REPORT OF PLANNING HEARING OFFICER ACTION Adam Stranieri, Planner III, Hearing Officer Bradley Wylam, Planner I, Assisting

December 15, 2021

ITEM NO: 3	
	DISTRICT 1
SUBJECT:	
Application #:	PHO-1-21Z-18-10-1
Location:	Southeast corner of 13th Avenue and Parkview Lane
	alignments
Zoning:	CP/GCP DVAO
Acreage:	5.16
Request:	Review of conceptual site plans and elevations per Stipulation 1.
	2) Modification of Stipulation 2 regarding dedicating 40 feet
	of right-of-way for the north half of Alameda Road and 30
	feet for the south half of Parkview Road.
	3) Technical correction to Stipulation 3.
Applicant:	Ed Bull, Burch & Cracchiolo PA
Owner:	North K LLC
Representative:	Ed Bull, Burch & Cracchiolo PA

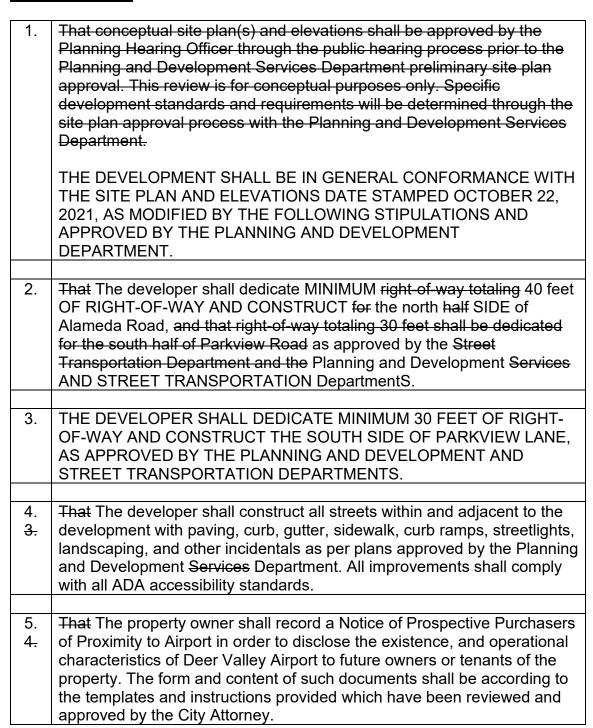
1) The applicant submitted a conceptual site plan and building elevations in compliance with Stipulation 1. This stipulation is recommended to be deleted and replaced with a requirement for general conformance to the plans submitted. Note that the subject property of this case is proposed to develop in conjunction with the property to the west in Rezoning Case No. PHO-1-21—Z-129-07-1 (companion case also heard on this agenda).

The conceptual site plan depicts two industrial shell buildings of approximately 106,200 and 184,400 square feet with an approximate height of 37 feet. Vehicular access is provided at multiple driveways along 15th Avenue, Alameda Road, and Park View Lane. Conceptual elevations include architectural features and details such as multiple colors, materials, metal canopies, offsets, reveals, and other façade relief. The proposal is consistent in scale and character with the land use pattern in the surrounding area.

Additionally, note that the cul-de-sac terminations shown on the site plan are not intended to be governed by the general conformance stipulation. Parkview Lane to the east and west will connect to adjacent parcels. Street construction and design is to be approved by the Street Transportation Department.
